1822 Bank Street

URBAN DESIGN BRIEF

OCTOBER 11, 2024

RESPONSE TO URBAN DESIGN COMMENTS

PATHWAYS TOWARD TRANSIT

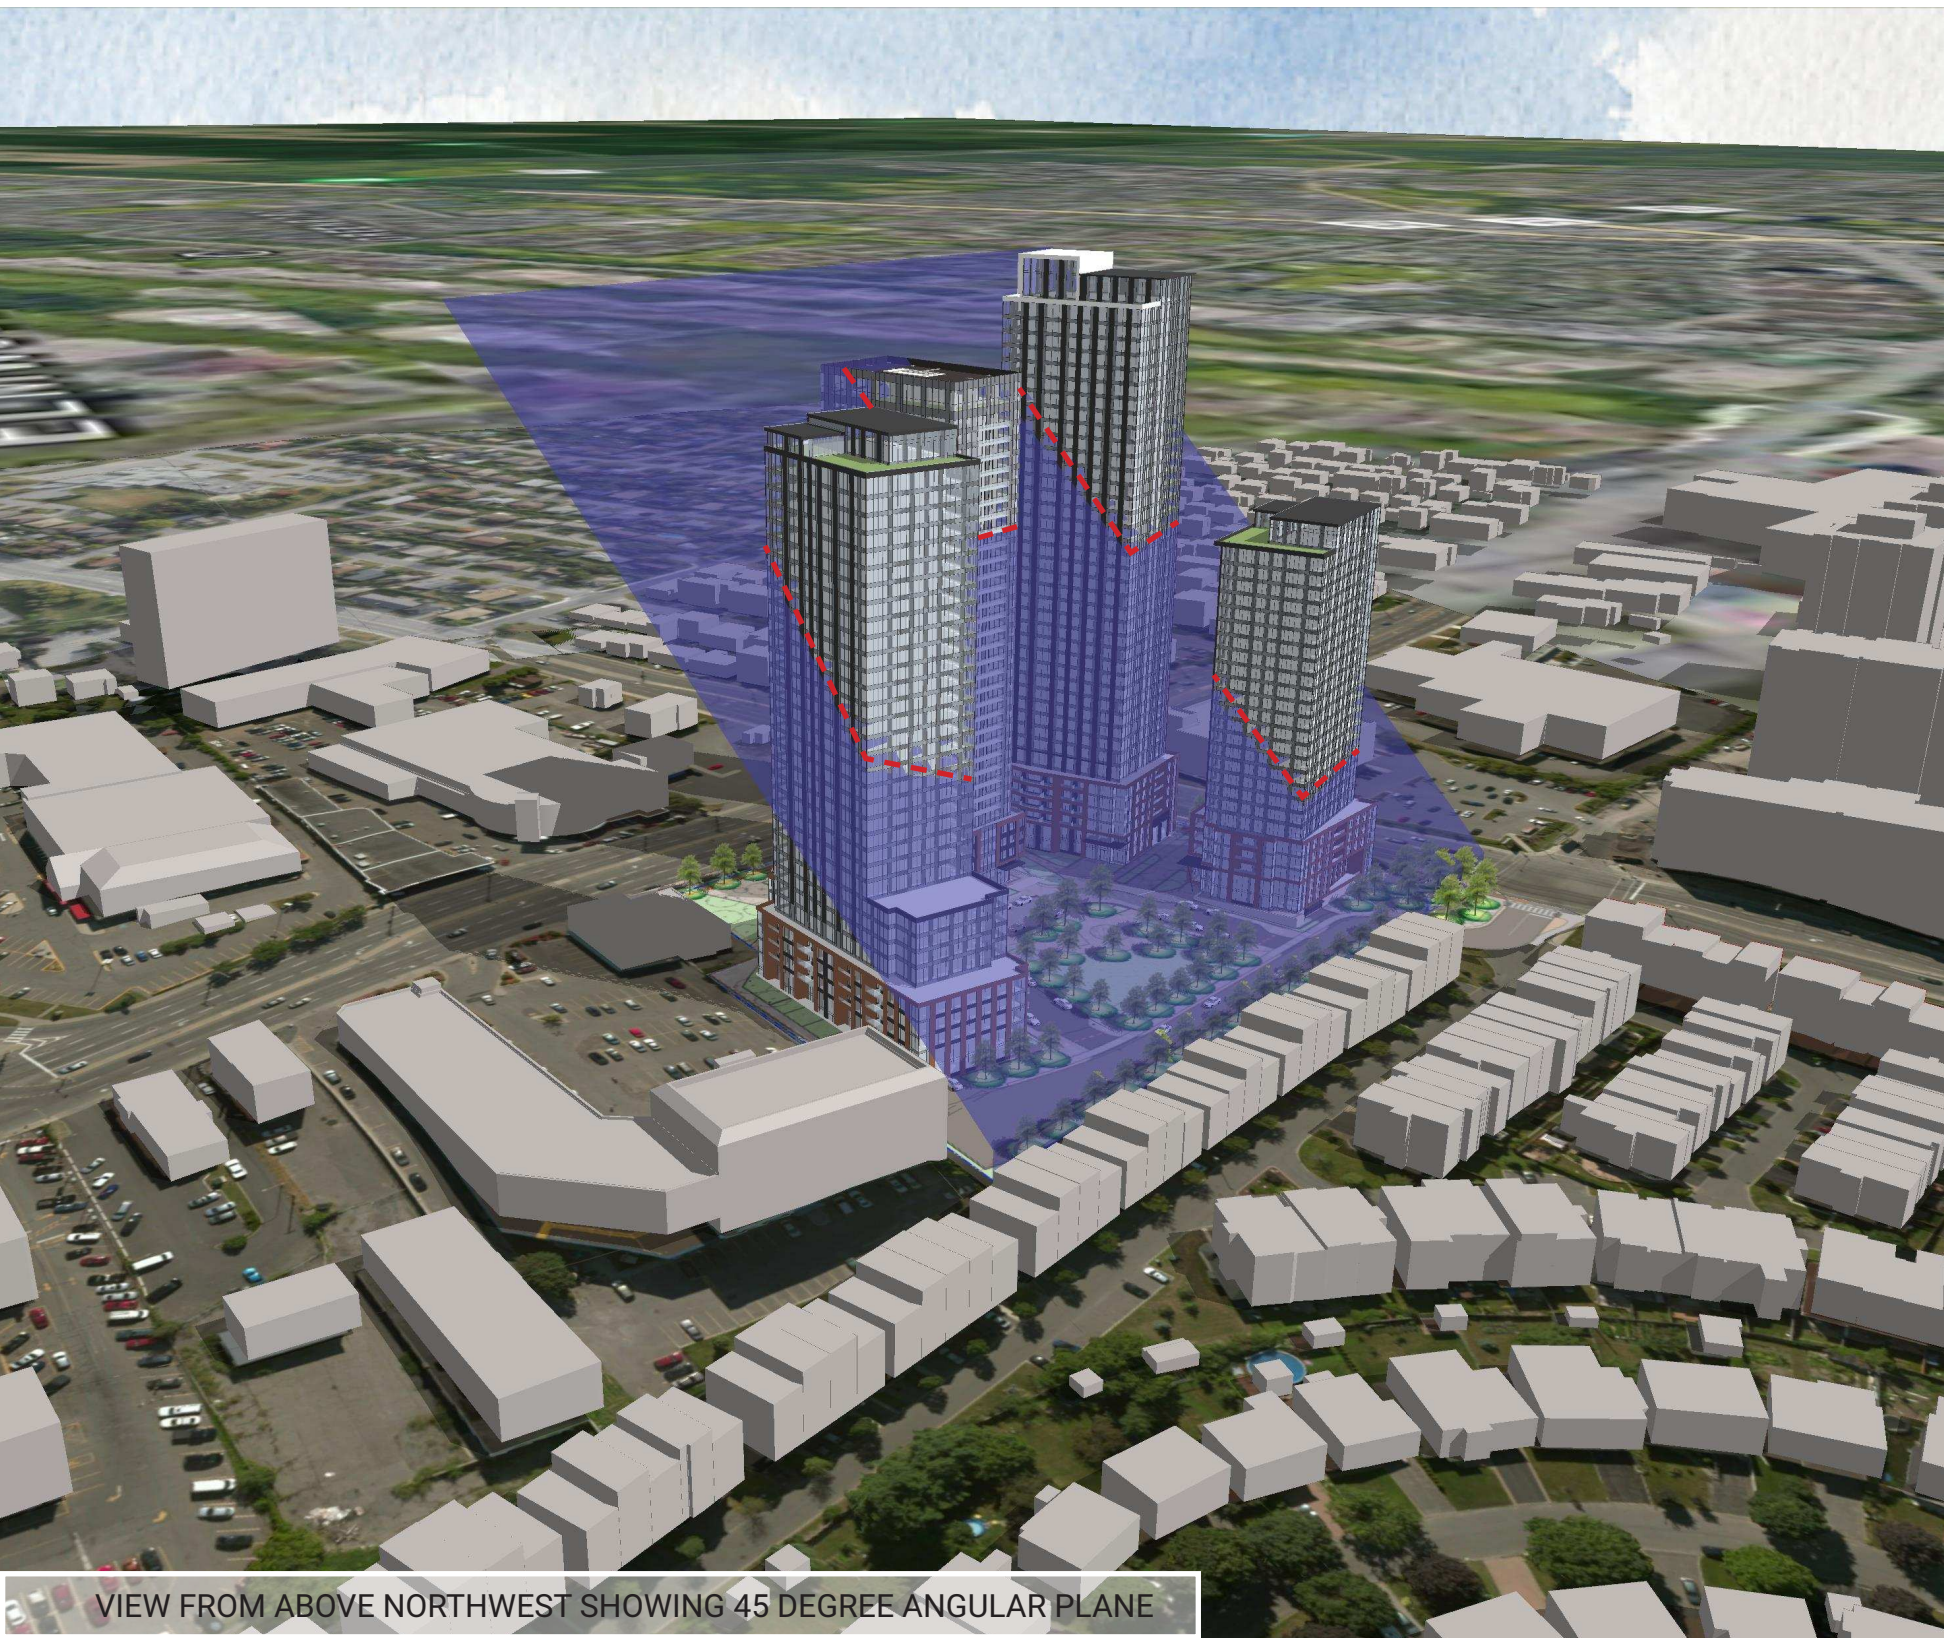
- e. The overall appearance of being an enclave and lack of connectivity with the rest of the broader community (particularly the lack of consideration of the planned context).

Applicant: We feel that creation of a sense of immediate community and a focal point is essential to the success of the project. In their current forms, both Bank St. and Walkley are relatively hostile roads – high traffic volume and low-quality public realm. While the proposed Bank Street Reconstruction will improve the public realm to a degree, there is a necessity for creating an open space that is separated from, at a fine scale/grain, and more landscaped than is possible on Bank or Walkley. The idea of the ‘central green space’ seeks to achieve this by making a second frontage that breaks from the busy-ness of the two major arteries. We feel that to ensure that this is not an enclave, the inclusion of a public right of way accessing this green space and through the site is important. Likewise, the recognition of desire lines through the site to access transit is enshrined in the design. Further multiple points of views inward and pedestrian porosity into the central space are provided from Bank and Walkley. These serve to invite pedestrians into the site – breaking down any sense of enclave.

VIEW FROM ABOVE NORTHWEST SHOWING 45 DEGREE ANGULAR PLANE

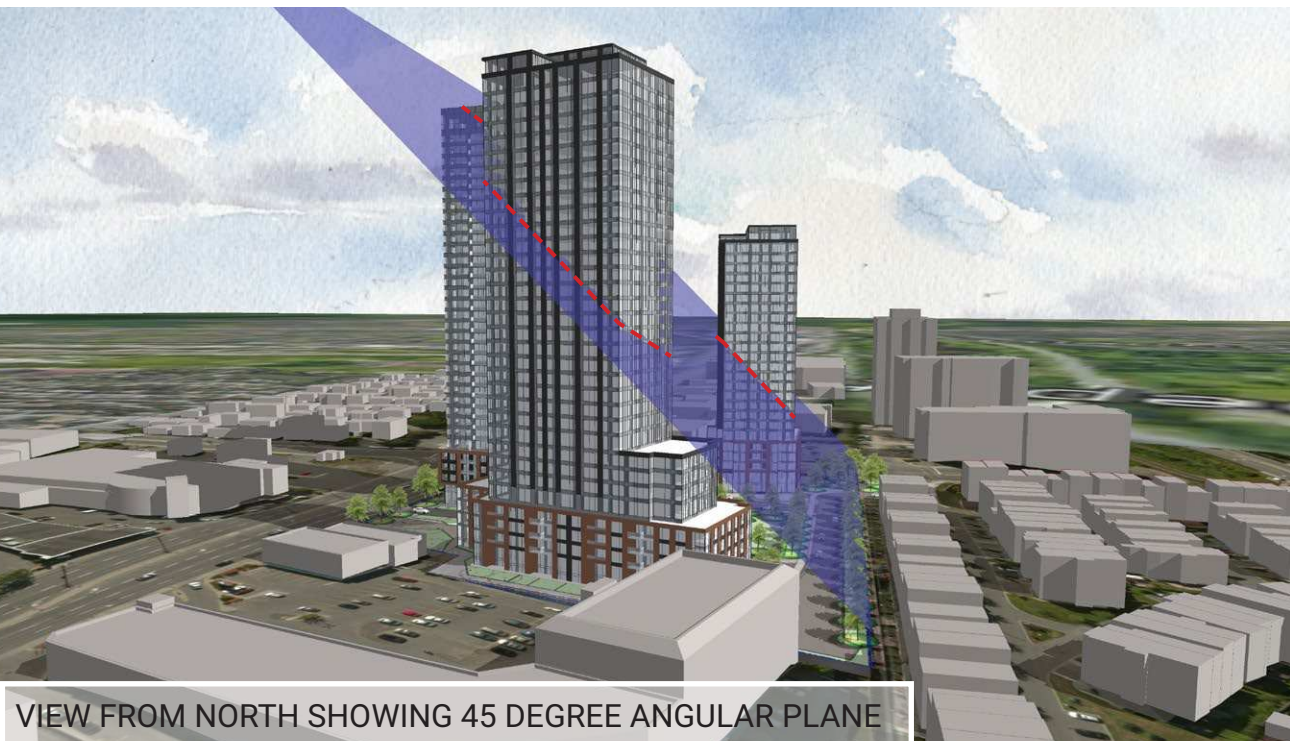
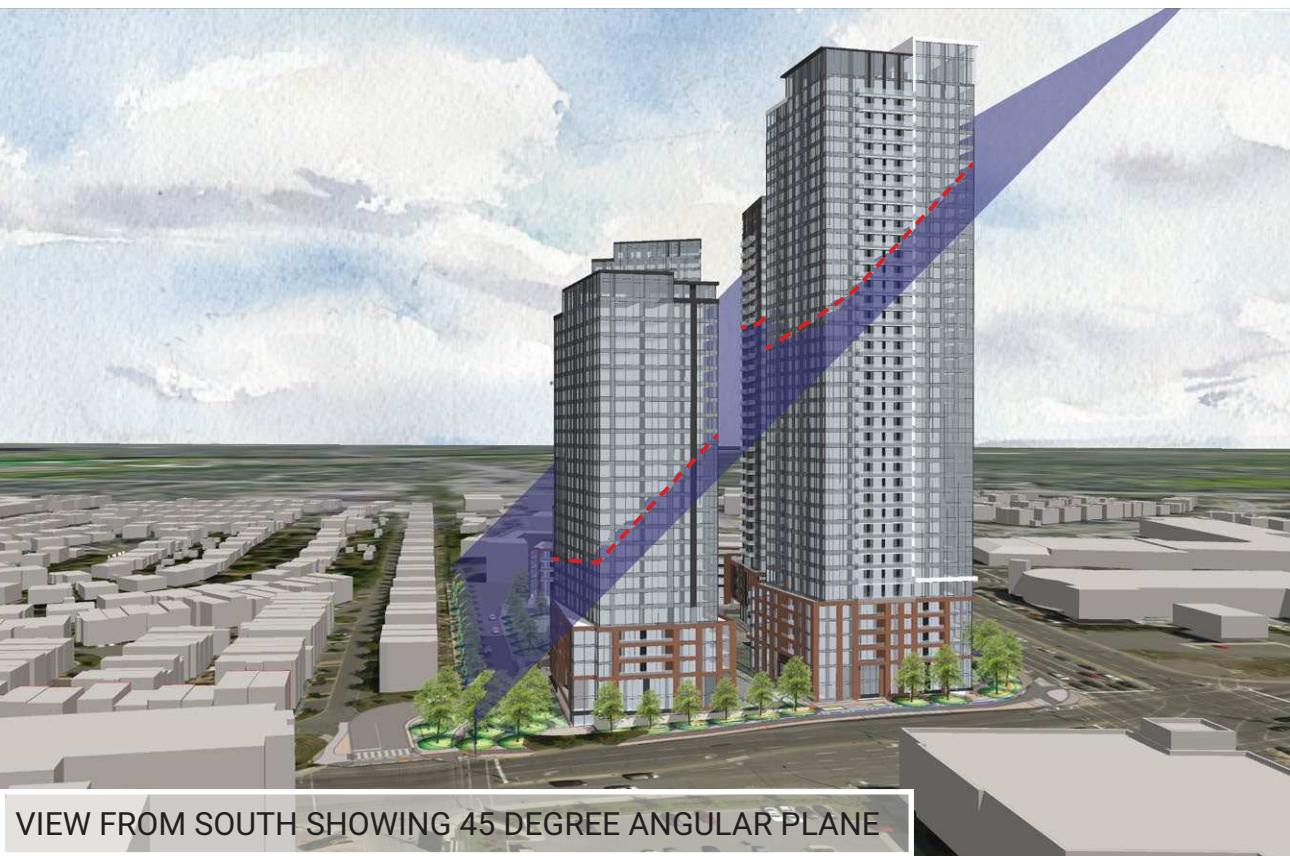
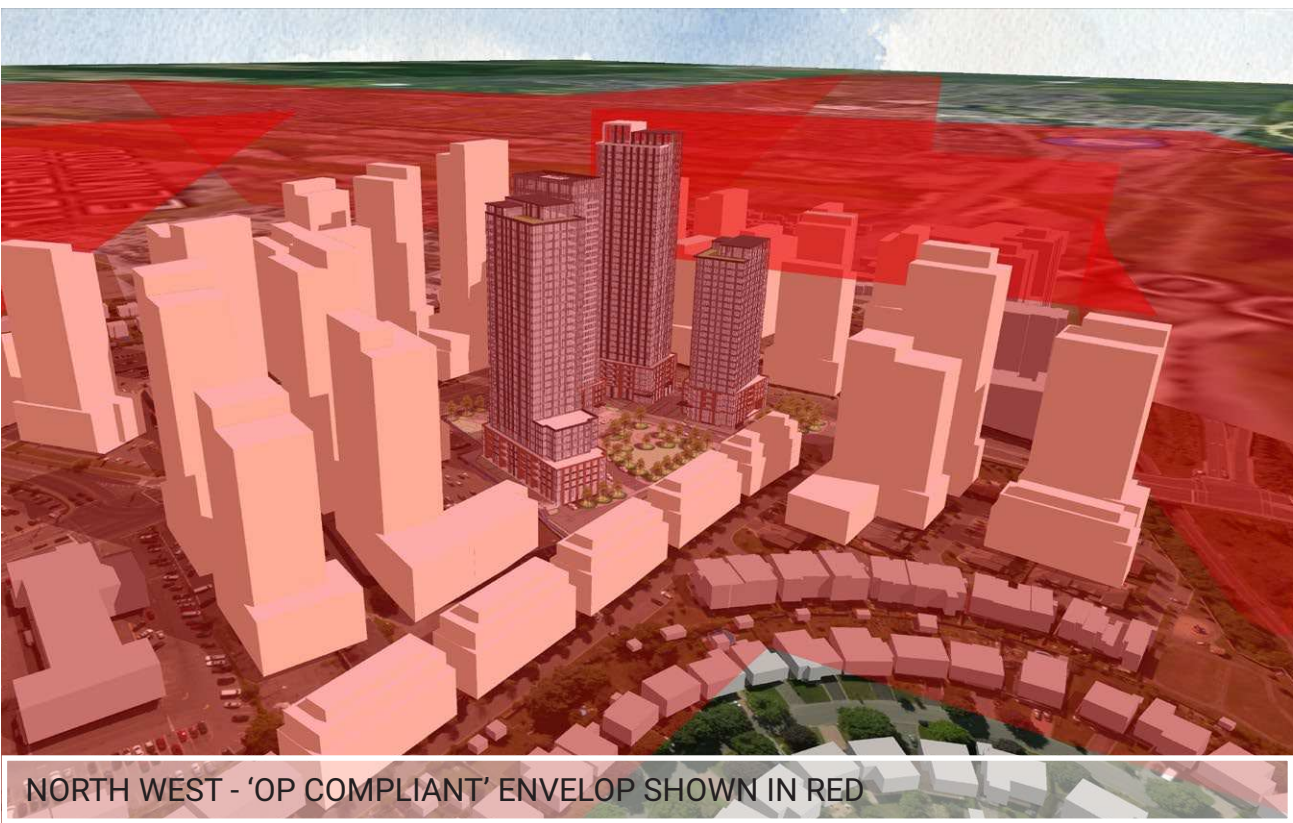
41. Ensure effective built form transition, guided by the application of angular planes.

Applicant: Please refer to the angular plane diagrams included in the UDRP submission set. We feel that the proximity to the transit station and future development potential under the OP justifies some elements of the development breaking the 45 degree angular planes. The trade-off the proposed development offers is providing the majority of the western edge as greenspace. This minimizes the number of the existing townhomes impacted by overlook / shadowing.
